TECHNICAL INFORMATION

TI0521

SiLine Snack S/M

Loud operating noise

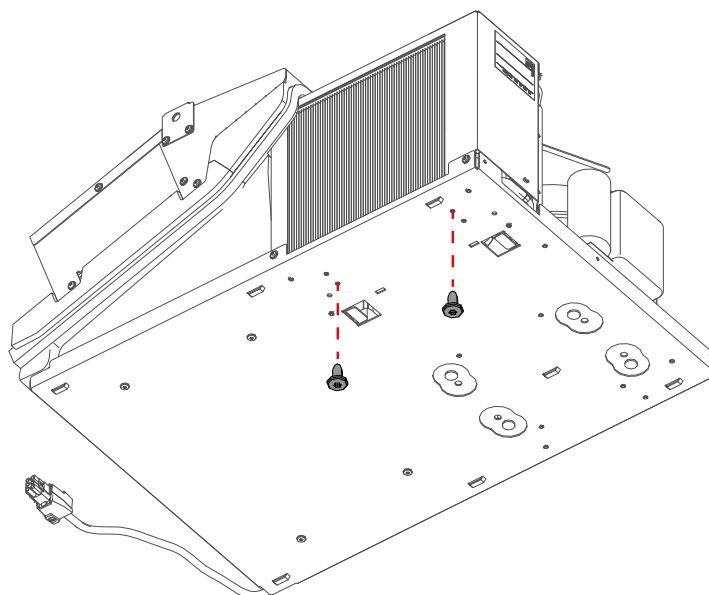
In rare cases a loud noise may occur in SiLine Snack machines during operation. This is caused by the condenser in the chiller unit having moved from its installation position. The displaced condenser causes other components to vibrate.

We recommend securing the condenser using two threaded screws M5 x 10. This prevents the condenser from moving and ensures quiet machine operation.

This problem has been rectified on all condensers supplied from the factory since March 2021.
